## Product Change Notification

**Product:** SAL M8 SMT Date of Publikation:  
2017-07-21

**Description of Change:** Change of soldering sheet

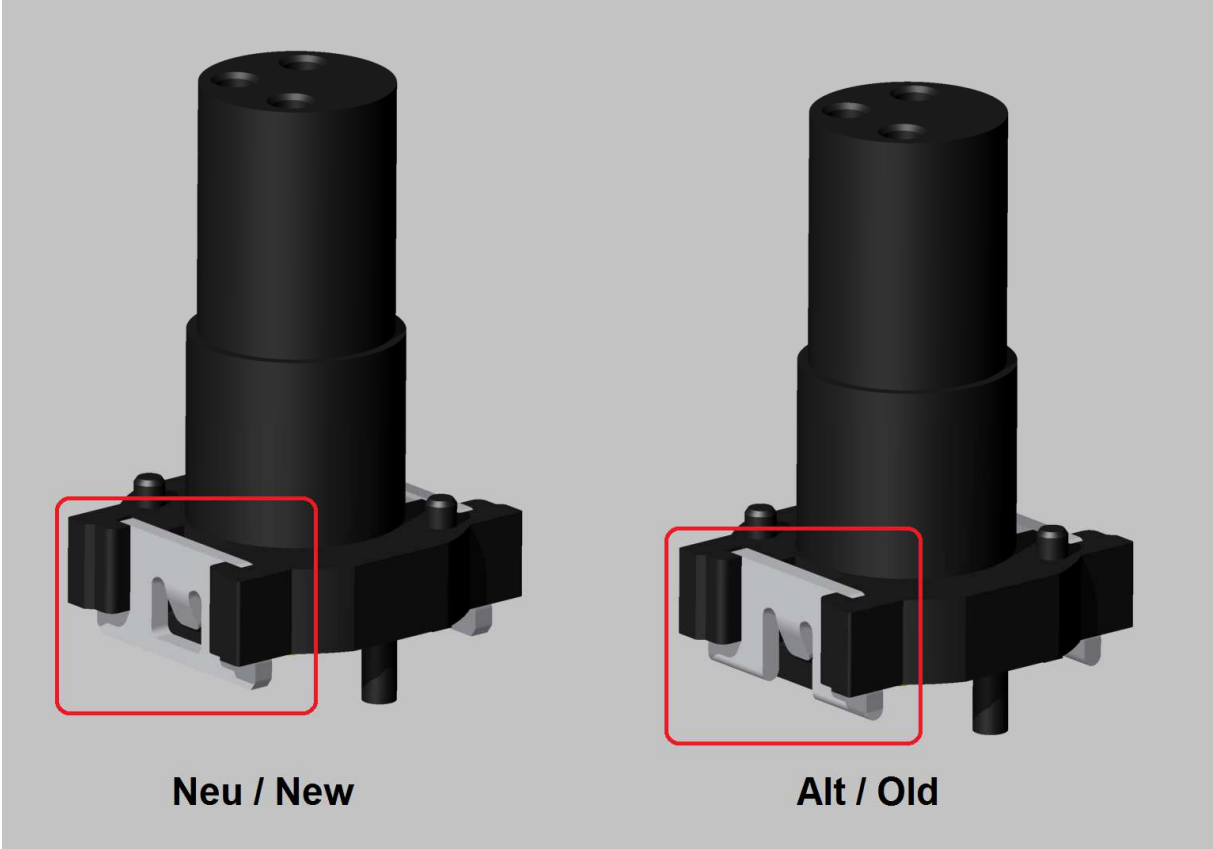
**Type of Change:** Minor (B) - change  
The opening on the bottom side of the soldering sheet is closed.  
There is no change regarding the pcb layout necessary.
